modified number pieces		26-02-06	
ref.	name	date	signature
modifications			
81	1	EN 6082	1/1
80	2	EN 6082	1/1
78	1	AISI 304	1/1
ref.	pieces	mat. and treatments	date
General machining tolerances UNI 5307-83			
Dimension	< 6	6-10	10-120
Linear Tol.	± 0.1	± 0.2	± 0.3
Angular Tol.	± 1'	± 30'	± 20'
designed by R.De Salvo			
G. Gennaro-PROMEC			
date 28-01-05 scale 1/1			
Title LIGO PROJECT			
HAM-005			
LIGO-0051145-01-D			
DETAIL MOUNTING BLADE			
sheet	144	A 1

80

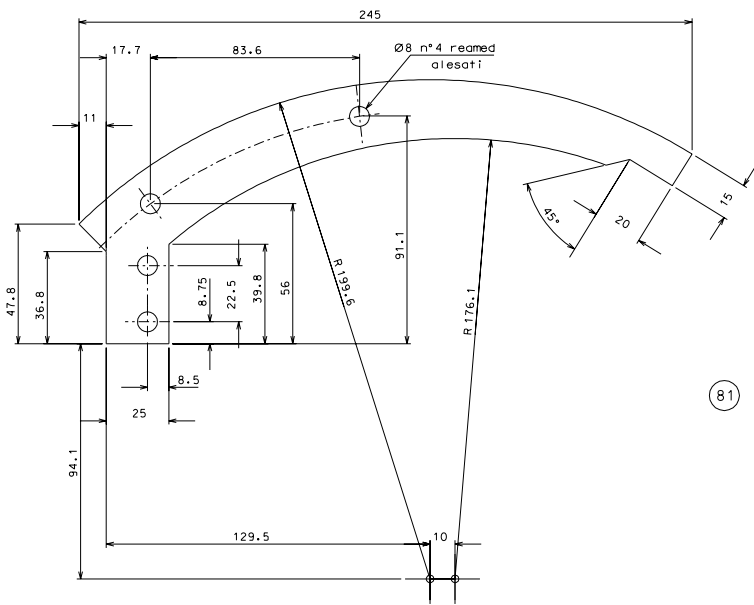
copy the missing dimensions from detail 81
